SYMBOL	ZONE	REVISIONS: DESCRIPTION	DATE	BY
	C-5	REVISED IN ACCORDANCE WITH AMENDMENT NO. 0002	18 APR 03

HARTWELL MAJOR REHABILITATION - PHASE 2
HARTWELL DAM AND LAKE
SWITCHYARD UPGRADE
DRAWING INDEX
SHEET 1
SAVANNAH RIVER GEORGIA AND S. CAROLINA

HARTWELL MAJOR REHABILITATION - PHASE 2
HARTWELL DAM AND LAKE
SWITCHYARD UPGRADE

CONTRACTOR STAGING AREA AND STORAGE PLAN

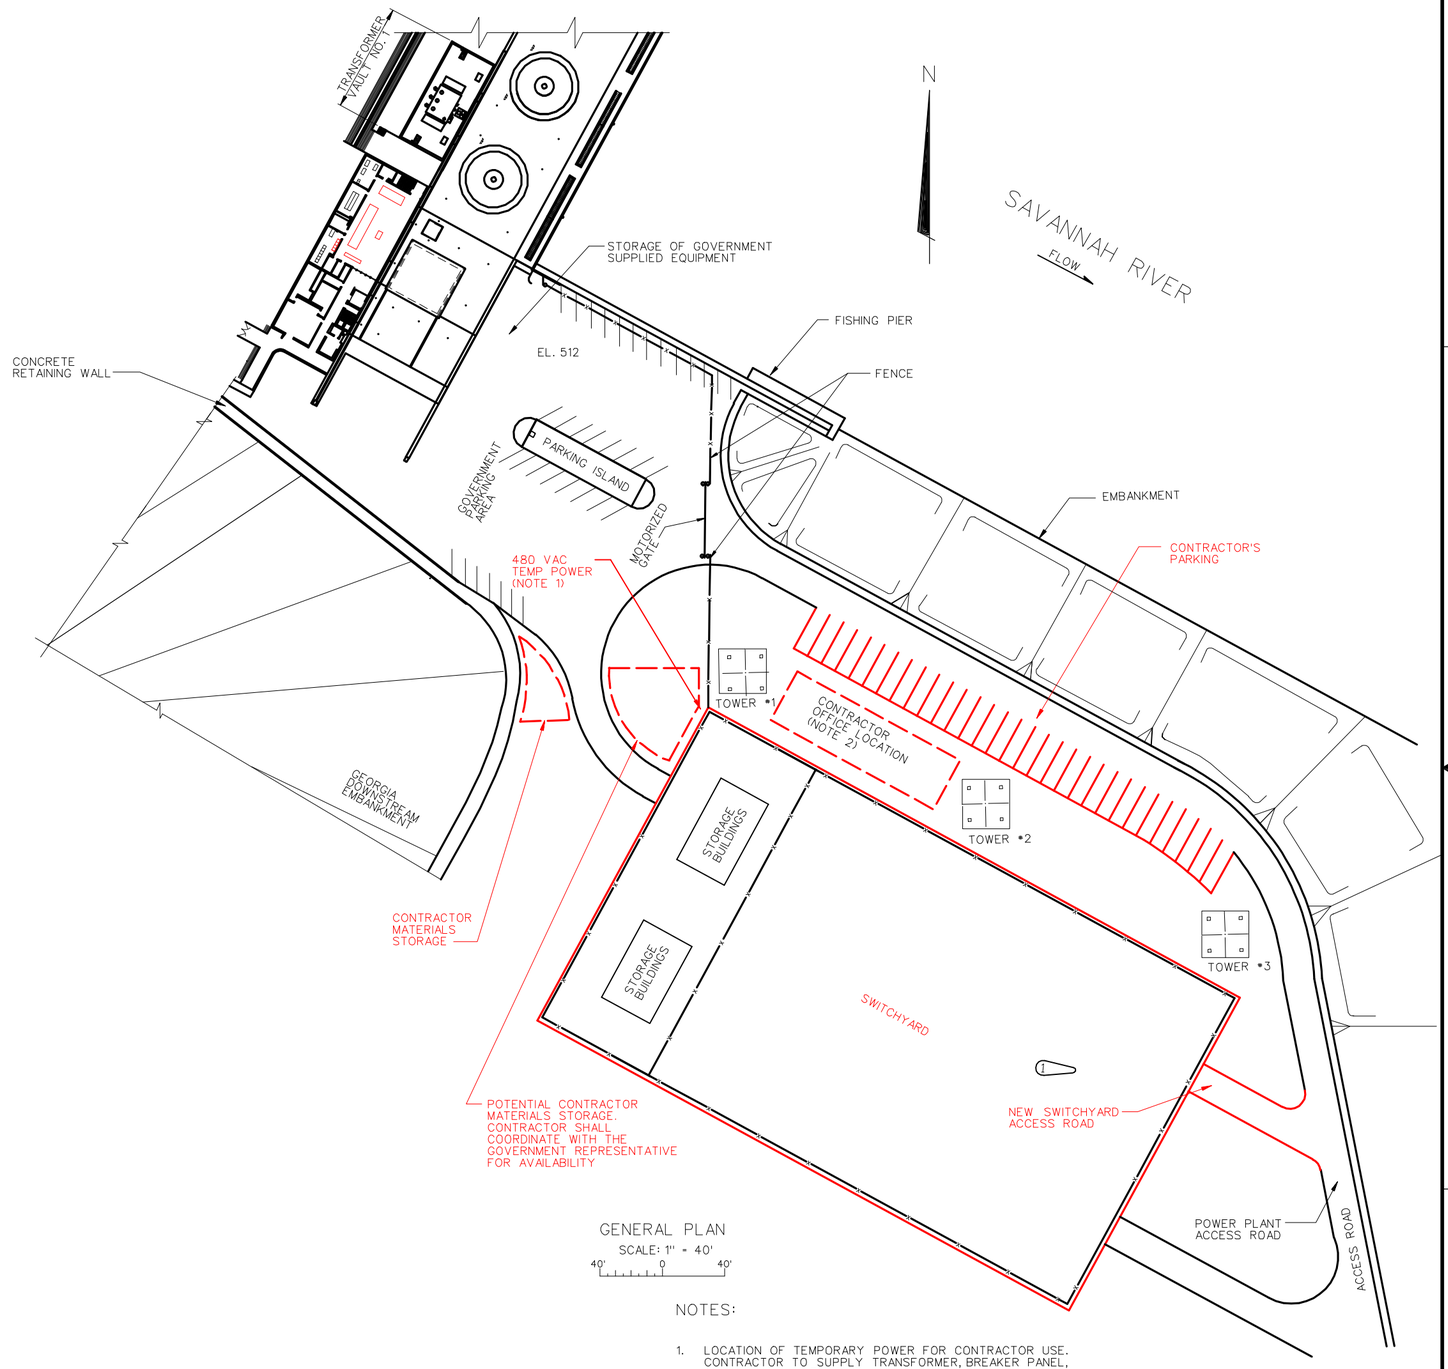
1. LOCATION OF TEMPORARY POWER FOR CONTRACTOR USE. CONTRACTOR TO SUPPLY TRANSFORMER, BREAKER PANEL, 460 VAC, 30 A., 3-PHASE.
2. EXACT LOCATION OF CONTRACTOR EQUIPMENT SHALL BE COORDINATED WITH THE COR.

DEMOLITION PLAN (PLAN OF EXST SWITCHYARD STRUCTURES AT THE FINISH GRADE EL 0'-0")

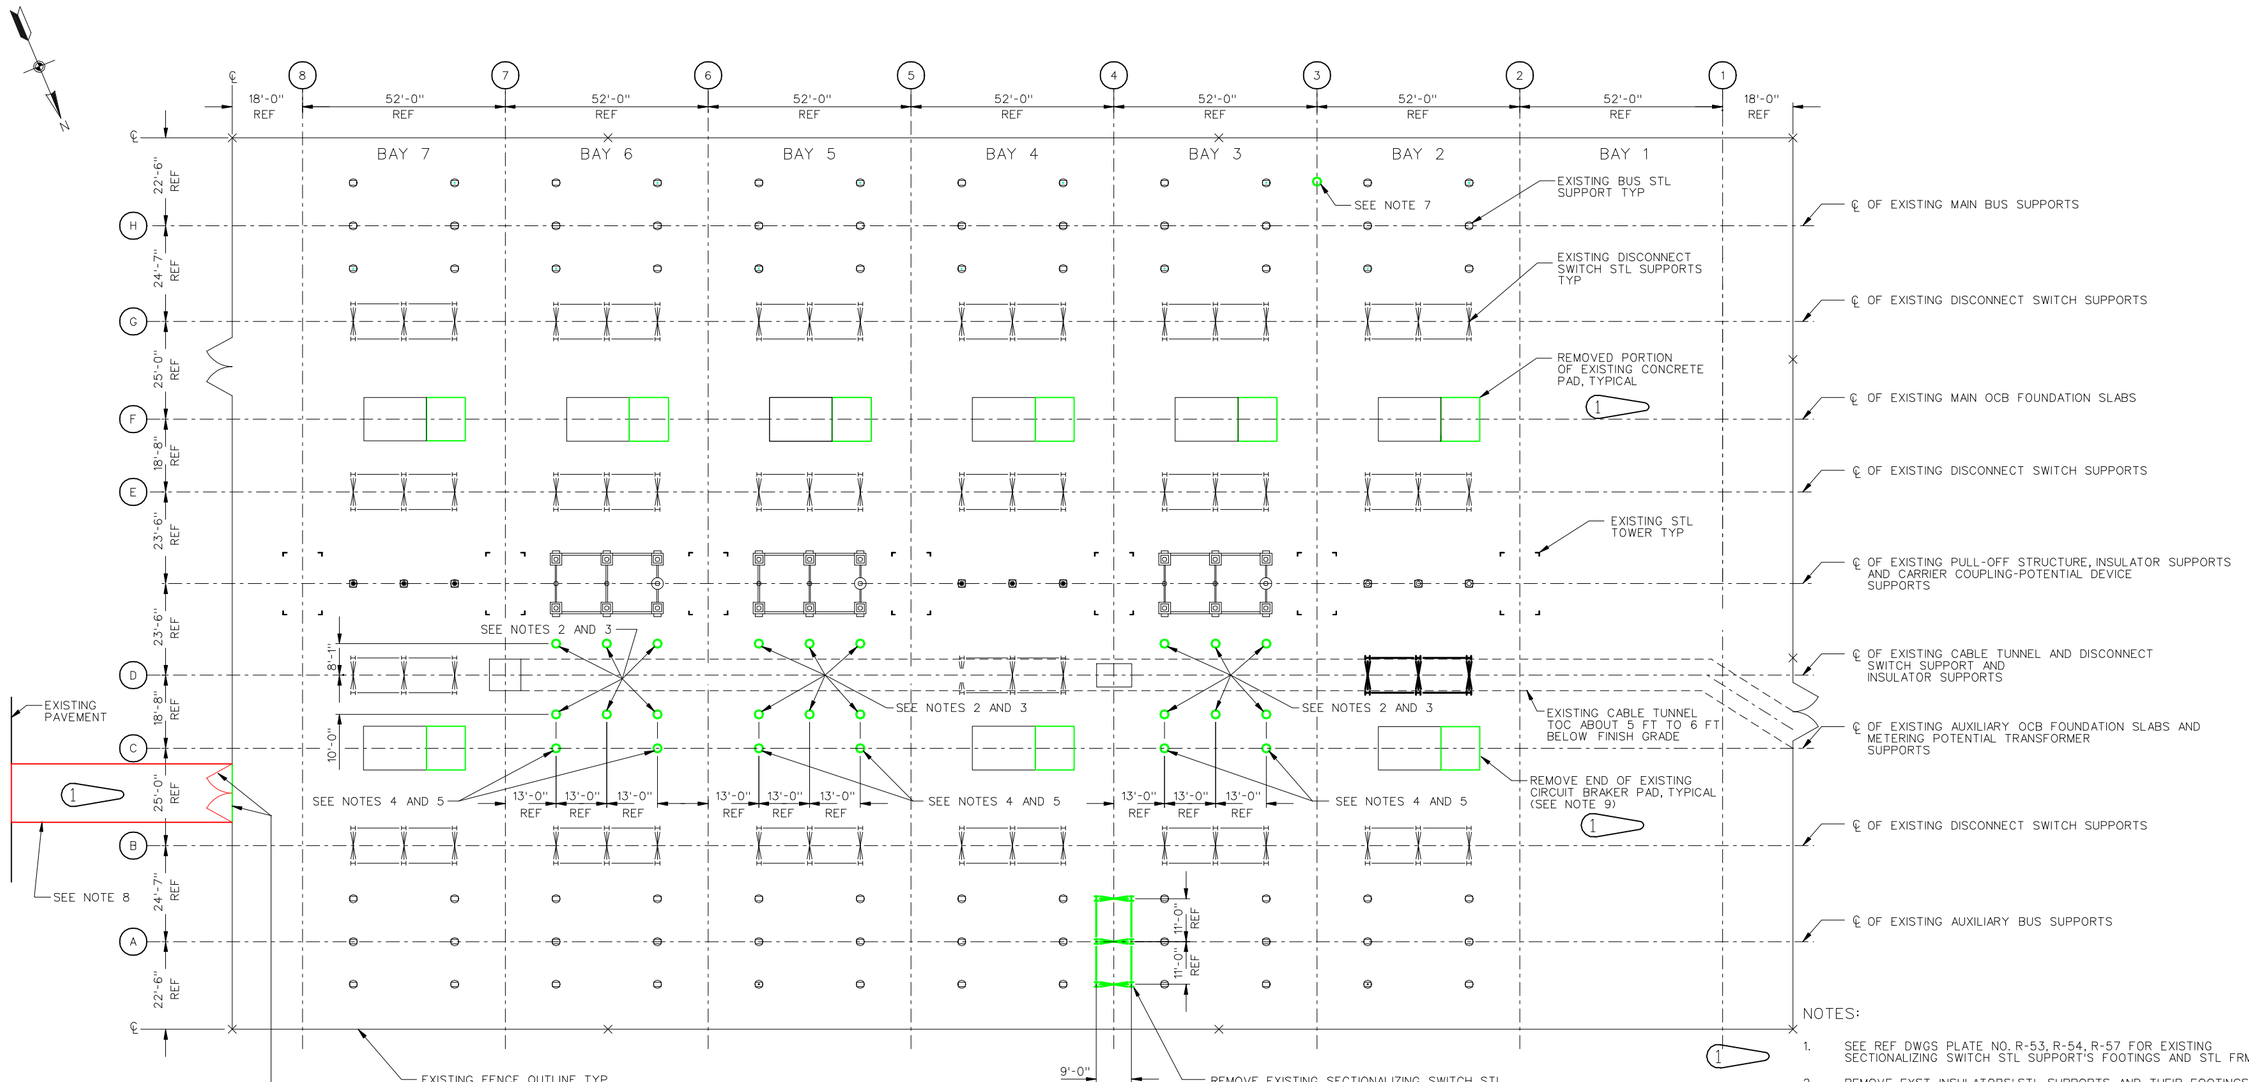
REMOVE EXISTING FENCE AS REQUIRED PROVIDE AND INSTALL A DOUBLE GATE (20' W X 8' H) AND POSTS THAT MATCH THE EXISTING GATE AND POSTS ALONG THE SAME SIDE BETWEEN THE GRID LINE (F) AND (G).

THE CONTRACTOR SHALL SUBMIT DESIGN, DWGS AND DETAILS OF THE GATE, POSTS AND FTGS TO THE COR FOR REVIEW AND APPROVAL PRIOR TO CONSTRUCTION.

PLAN - SWITCHYARD LAYOUT
EQUIPMENT REMOVAL

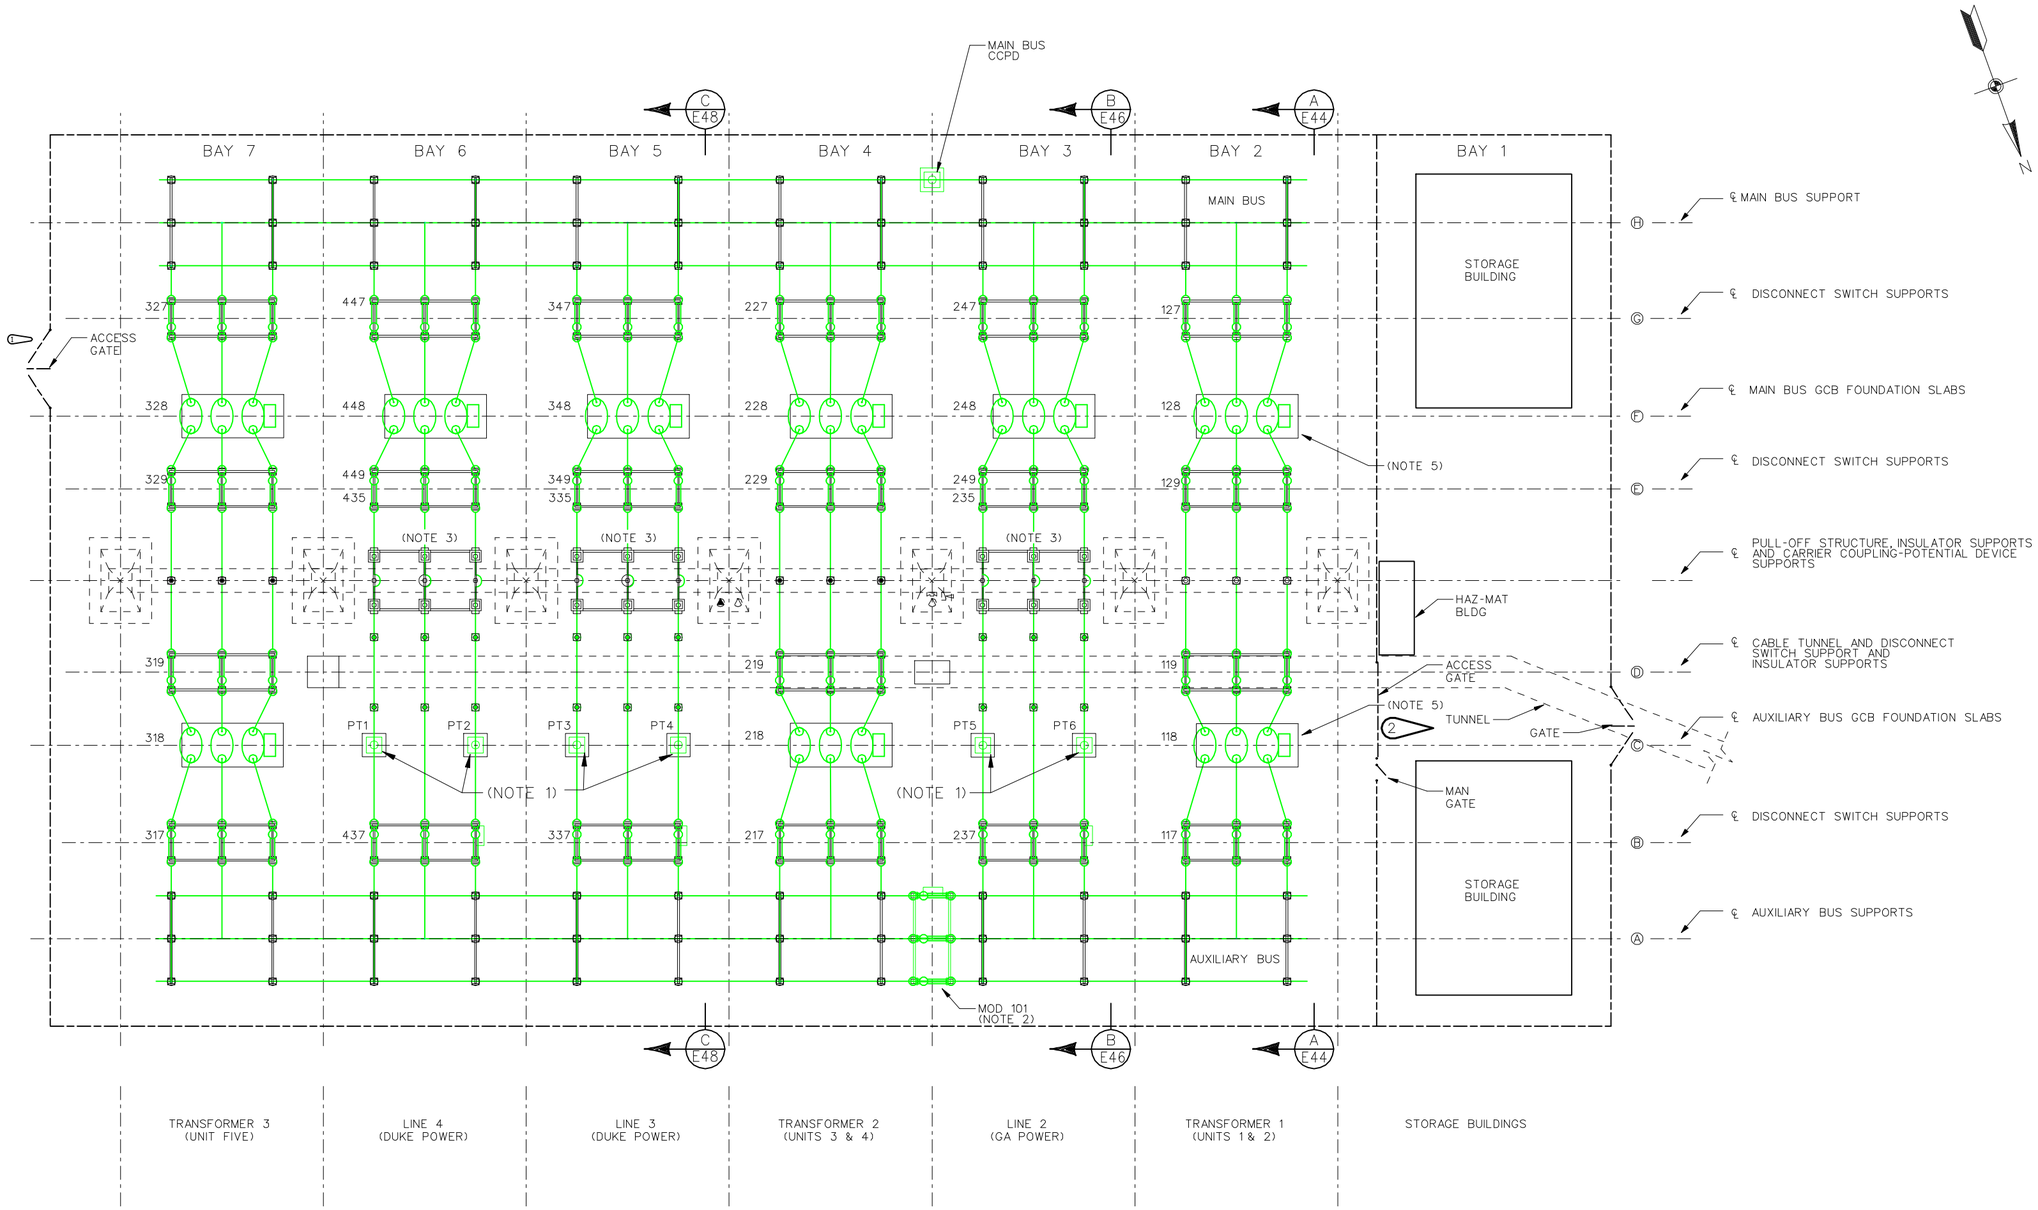
1. LINE PT'S SHALL BE RELOCATED UNDER THE EAST END OF THE MAIN AND AUXILIARY BUS. SEE DRAWING E-42.
2. SEE DRAWING E-54 FOR EQUIPMENT REMOVAL DETAILS.
3. LINE METERING EQUIMENT DETAILS ARE SHOWN ON DRAWINGS E-52 AND E-53
4. FOOTINGS FOR EQUIPMENT BEING REMOVED OR RELOCATED ARE ALSO TO BE REMOVED.
5. SEE DRAWING E-54 FOR PAD CHANGES REQUIRED.

PLAN-SWITCHYARD LAYOUT

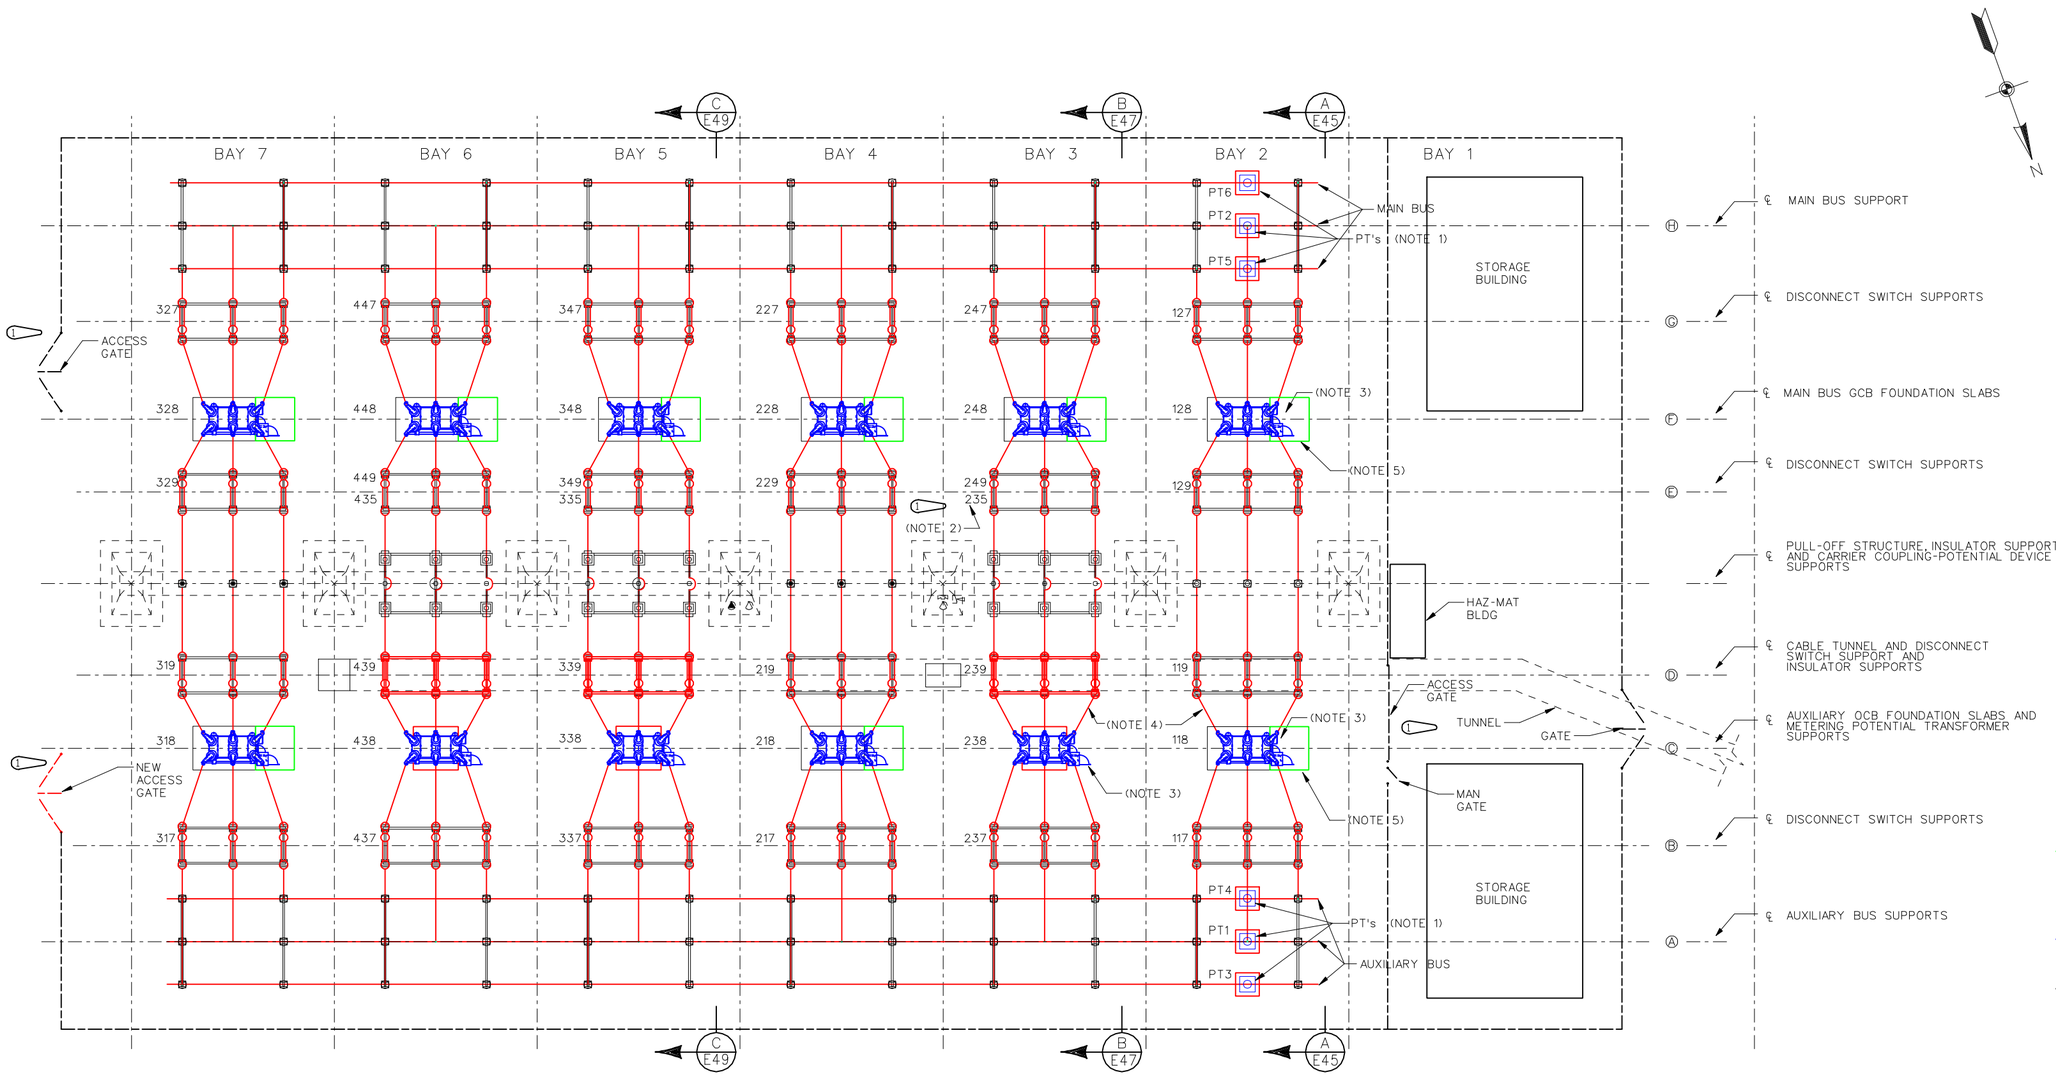
1. SYNCHRONIZING PT'S RELOCATED FROM LINE BUS TO EAST END OF MAIN AND AUXILIARY BUSES. PT'S NO. 1 AND 2 SHALL BE INSTALLED ON PHASE B. SEE DRAWING E41. NEW STEEL PEDESTAL AND CONCRETE FOOTINGS REQUIRED.
2. DEVICE NUMBERS 235, 335, AND 435 IDENTIFY THE GROUNDING SWITCH.
3. CONTROL CONDUITS SHALL BE INSTALLED AS SHOWN IN DETAILS ON DRAWING E-54.
4. TEMPORARY CONNECTIONS BETWEEN NEW GCB'S AND EXISTING DISCONNECTS SHALL BE USED UNTIL THE DISCONNECTS ARE REPLACED, SHALL BE 750MCM STINGER CABLES. PERMANENT BUS TUBING SHALL BE INSTALLED AT THESE LOCATIONS WHEN NEW DISCONNECTS ARE INSTALLED.
5. A SECTION OF THE EXISTING CONCRETE BREAKER PAD SHALL BE REMOVED TO FACILITATE CONDUIT ROUTING FROM THE TUNNEL TO THE NEW BREAKER CONTROL BOX AS DONE IN BAYS THREE, FIVE, AND SIX WITH THE NEW BREAKER PADS. SEE DRAWING E-54 FOR MORE INFORMATION.

TUNNEL PENETRATIONS

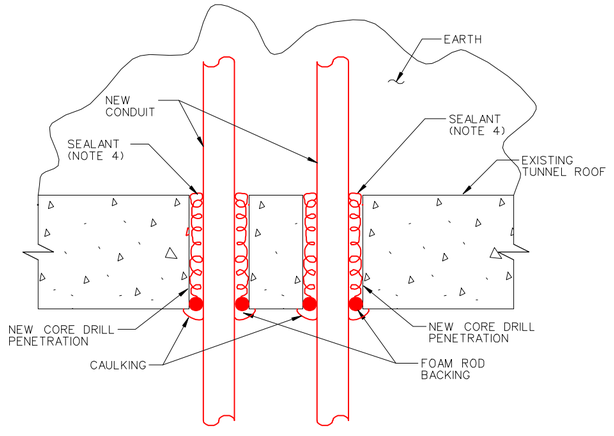
1. EXISTING BUS SUPPORT INSULATORS SHALL BE CLEANED, AND TESTED AS PER SPECIFICATION SECTION 16050 BEFORE REUSE.
2. AFTER EQUIPMENT IS REMOVED, REMOVE EXISTING CONDUIT BACK TO THE TUNNEL. SEAL AND ABANDON PENETRATION INTO TUNNEL. (1)
3. HEIGHT OF PULL BOX ABOVE BREAKER PAD AND SWITCHYARD FLOOR SHALL BE DETERMINED BY THE CONTRACOTR TO ALLOW EASE OF CONDUIT INSTALLATION.
4. SEALANT SHALL BE A WEATHER, MOISTURE, CHEMICAL RESISTANT SUBSTANCE SUITABLE FOR SEALING EMBEDDED CONCRETE PENETRATIONS. "REVERE X-JT SEAL AND F-126 JOINT FILLER" ARE SUITABLE SEALANT MATERIALS. CONTRACTOR SHALL SUBMIT FOR APPROVAL.
5. REFER TO CONDUIT AND CABLE SCHEDULES FOR REQUIRED CONDUITS TO NEW GCB'S.
6. CONTRACTOR SHALL REMOVE END OF EXISTING BREAKER PADS TO ALLOW ACCESS TO CONTROL BOX BY CONDUITS BELOW. SUFFICIENT CONCRETE SHALL REMAIN FOR BREAKER SUPPORT AS WITH NEW CONCRETE PADS.
